Docket No. LC 77

In the Matter of
PACIFICORP, dba PACIFIC POWER,
2021 Integrated Resource Plan.

Staff Report

Figure 1: 2020 Coal Fuel and Production Expenses

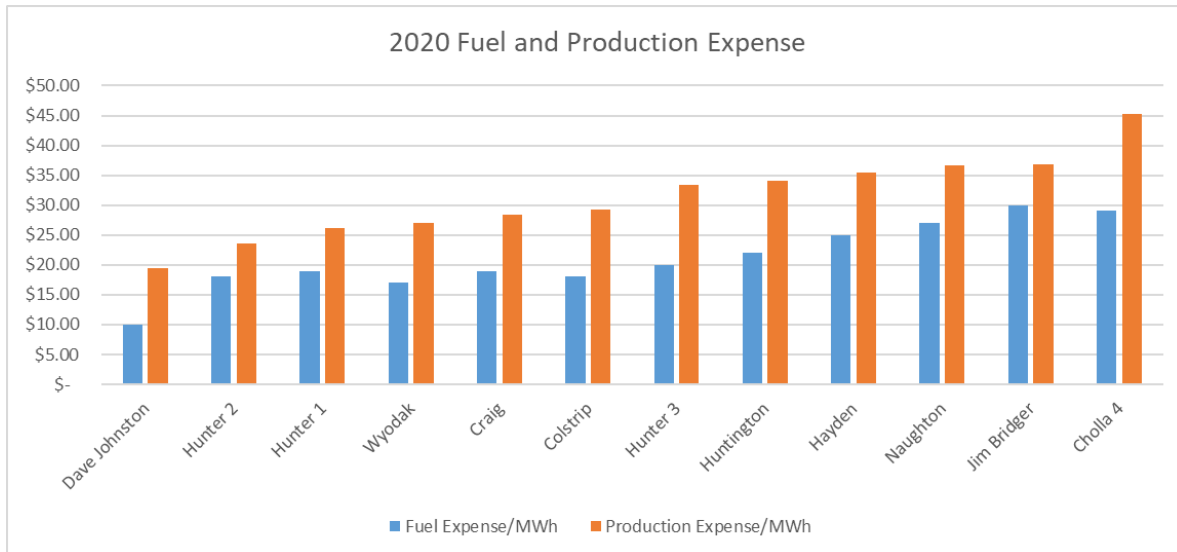
Staff has been skeptical of Jim Bridger 3 and 4 remaining in the IRP preferred portfolio through 2037 in part because of the units’ high variable costs. Staff would like to further discuss variable costs at this time, as well as the fixed costs of keeping the plant online to provide flexible capacity. While the high variable costs at these units make the plants expensive from an energy perspective, the high nameplate capacity of the plant (about 2,300 MW in total and about 1,425 MW owned by PacifiCorp) help to distribute any fixed costs over a higher number of MW of capacity.

FERC Form 1 data from 2020 shows that Jim Bridger units had the highest fuel and production expenses of any coal units on PacifiCorp’s system in 2020.²⁵ This is part of why the inclusion of Jim Bridger 3 and 4 as coal units through 2037 has been surprising.
